FIRE SAFETY INSPECTION REPORT

TOPAZ DRESSES LTD.

ACCORD ID: 12395

November 15, 2015

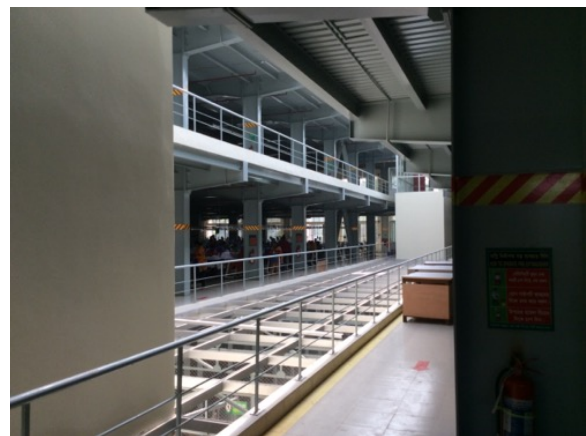
F-5	Fire Rated Construction	The exit stairs on the ground and second floors were open to factory areas due to unenclosed stairwells.	Separate the exit stairs from from work areas and other building spaces on all floor levels by minimum 2-hr fire-rated construction.	Within 3 months
-----	-------------------------	--	--	-----------------

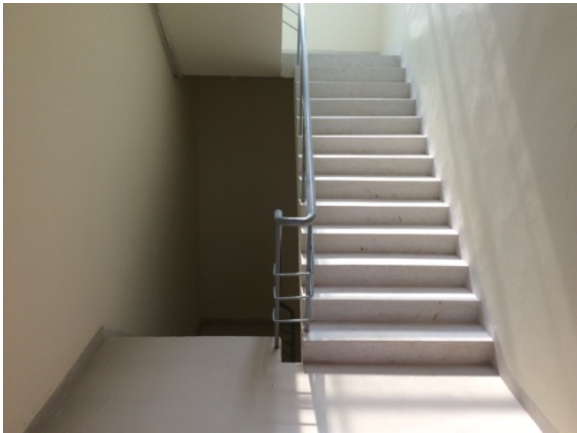
F-12	Egress	Handrails are not provided on both sides of the exit stair.	Provide handrails on both sides of the exit stair and ramp. New handrails shall have a minimum height of 865 mm (34 in.) and a maximum height of 965 mm (38 in.) as measured from the leading edge of the tread. Intermediate handrails shall be provided when the stair width exceeds 2.2 m (87 in.) .	Within 3 months
------	--------	---	---	-----------------

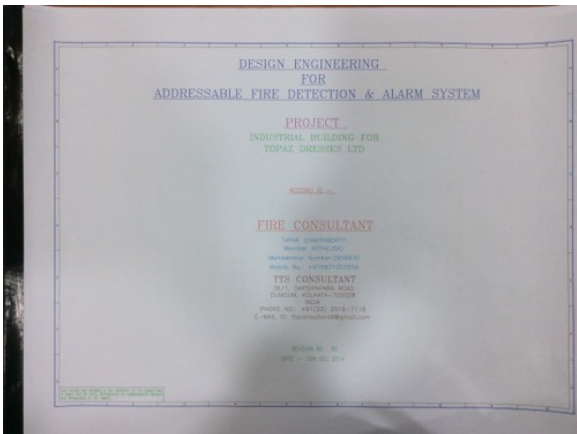
F-14	Fire Protection	Fire alarm system installation requires detailed review to confirm compliance with NFPA 72 and ACCORD standards.	Submit as-built drawings, testing records, equipment certification and other relevant documentation to the ACCORD for review and approval.	Within 1 month
------	-----------------	--	--	----------------

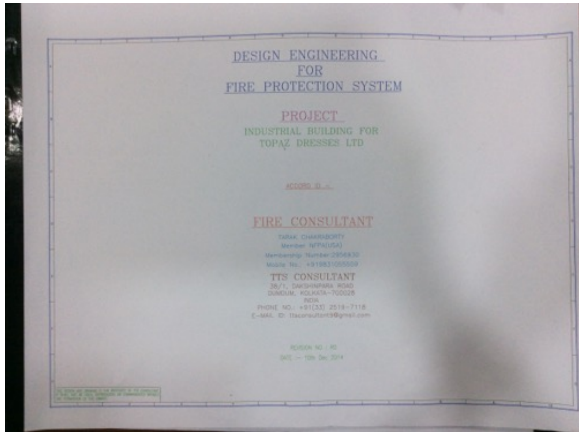
F-15	Fire Protection	Fire pump installation requires detailed review to confirm compliance with NFPA 20 and ACCORD standards.	Submit as-built drawings, testing records, equipment certification and other relevant documentation to the ACCORD for review and approval.	Within 1 month
------	-----------------	--	--	----------------

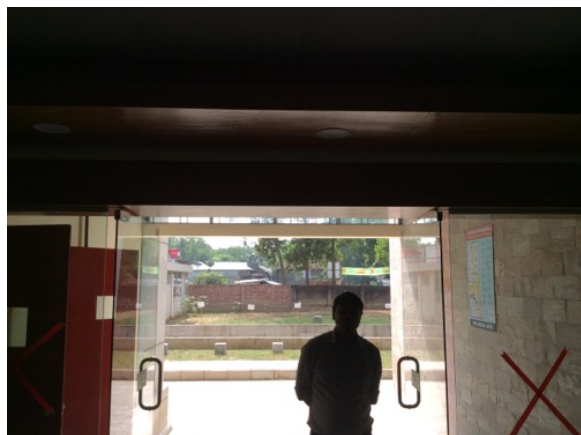
F-18	Fire Protection	Inspection, testing and maintenance of the standpipe system is not in accordance with NFPA 14.	Inspect, test and maintain the standpipe system and keep written records on-site, in accordance with NFPA 14 and ACCORD standards.	Within 3 months
F-19	Egress Lighting	Exit signage at office area was not provided at a building exit.	Provide exit signs above all building exits to the exterior, all doors to the exit stairs and along all paths of travel where a change of direction is not obvious.	Within 1 month
